KELLER SPRINGS LOFTS

RFI

RFI #: 163
 Date: 6/26/2012
 Job: EB-02 Keller Springs Lofts
 Phone: 877-777-5115

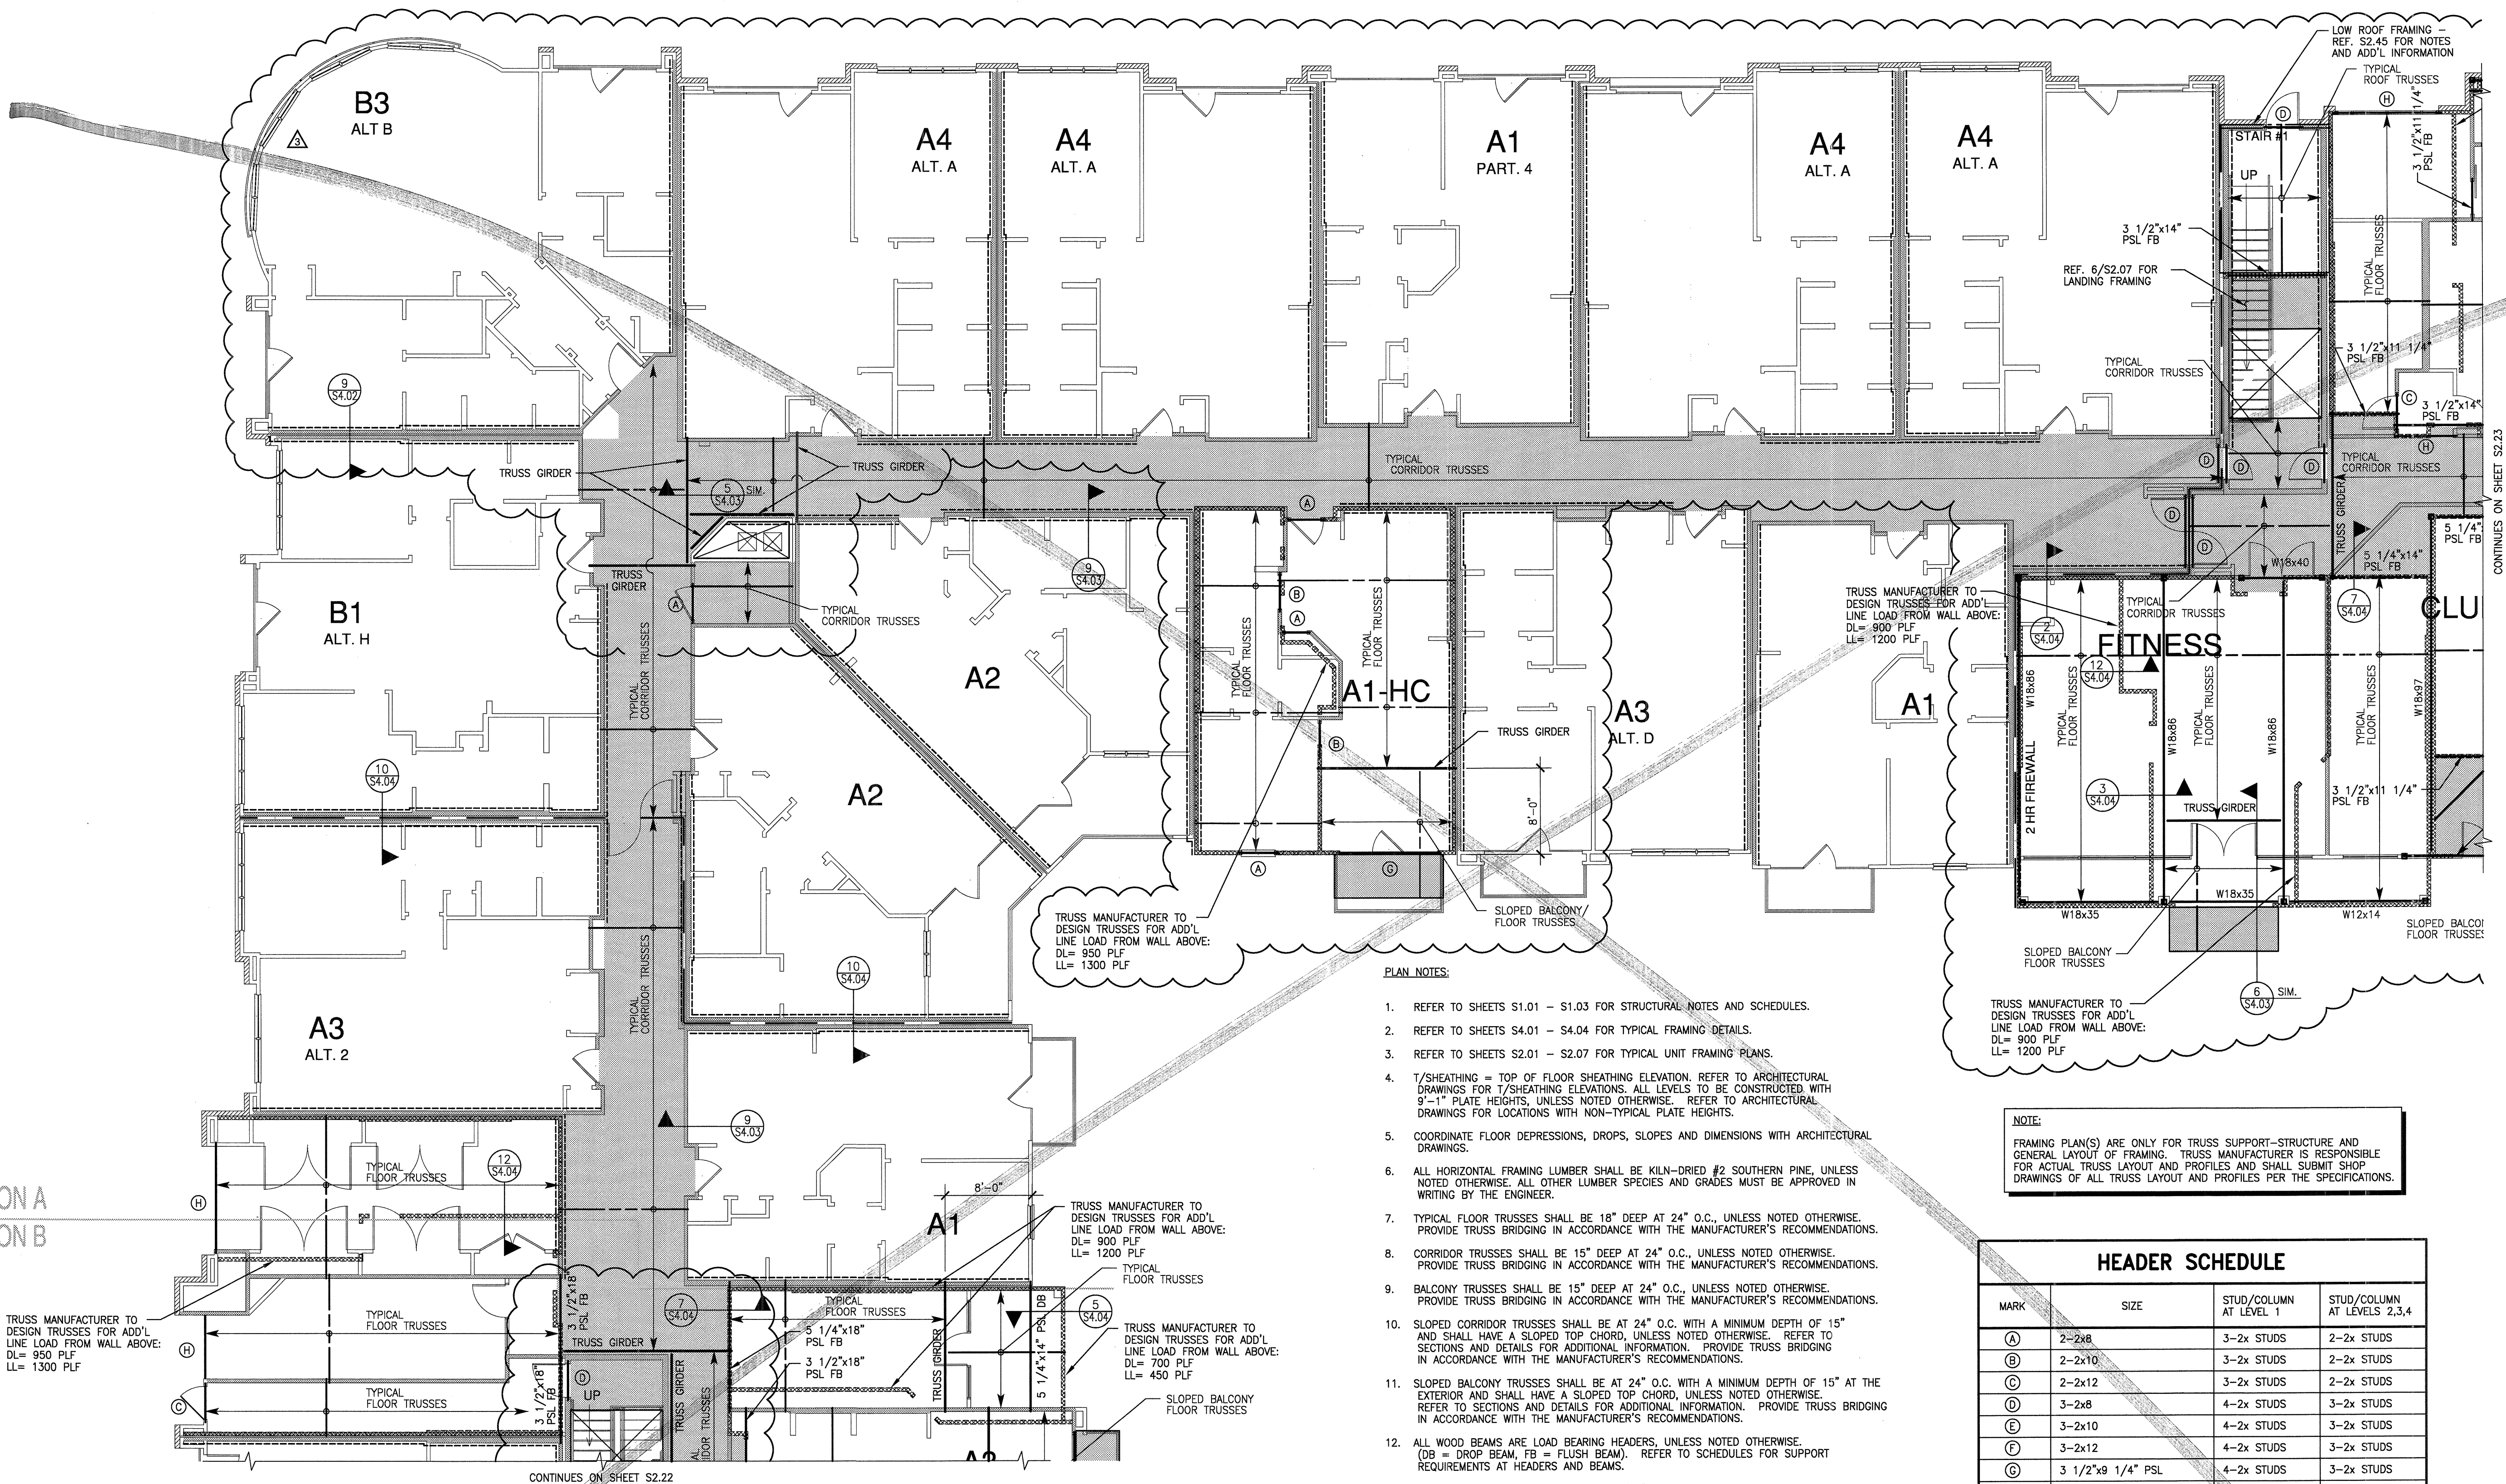
Request: **Date Required:** 11/3/2012
We need to confirm that there is no low roof at the south entry to the west building. S2.22 shows a 5 1/4" x 14" PSL D.B. & low roof framing and trusses. S2.23 shows open to below which would mean no low roof framing. S2.42 shows roof trusses with 3 1/2" x 11 1/2" D.B. Ref. 3/S5.02 which shows roof detail. 3.2B, 3.3B, & 3.4B shows open to below which would mean no low roof. 1/4.2 shows no low roof, 5/ 8.6A shows no low roof. Please confirm there is no low roof in this area.

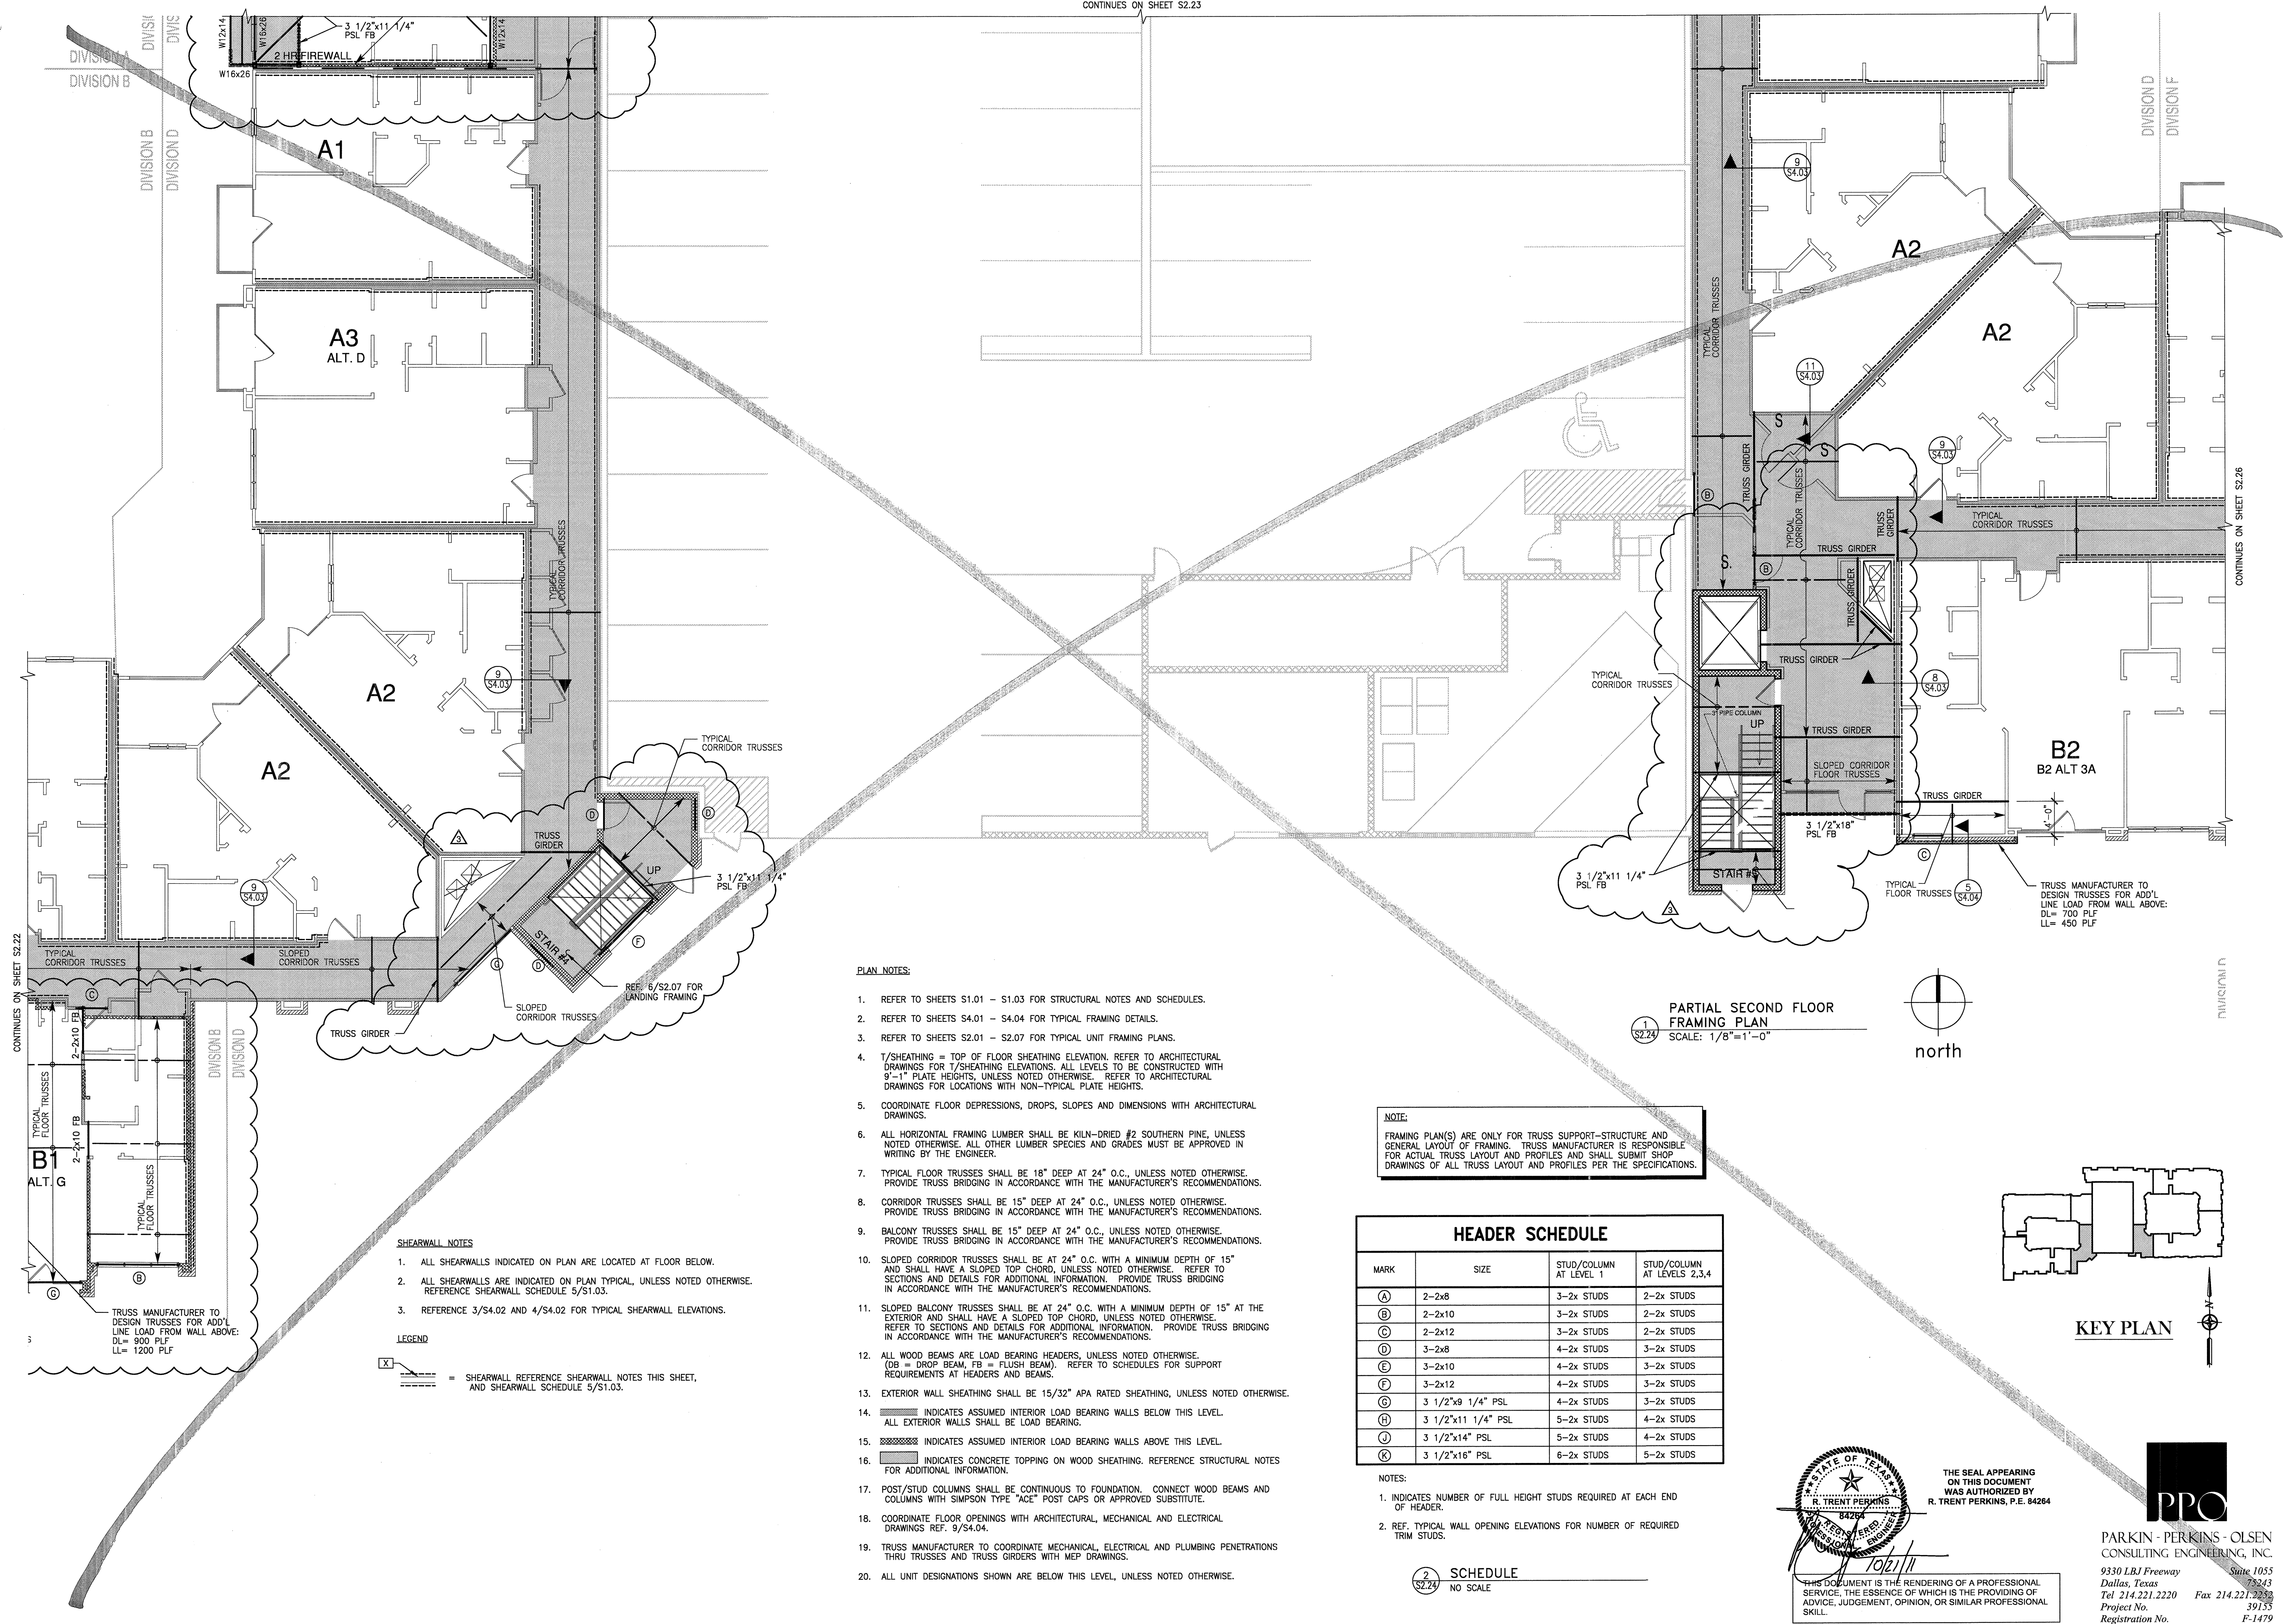
Request:
 S2.1 shows the shortest new grade beam location north of the elevator. This new grade beam is located under a critical load bearing triple girder that supports the corridor floor trusses. The supporting stud packs for this girder will have to be removed to cut and remove existing slab and install new grade beam. Please provide a temporary bracing detail for this area so we can proceed.
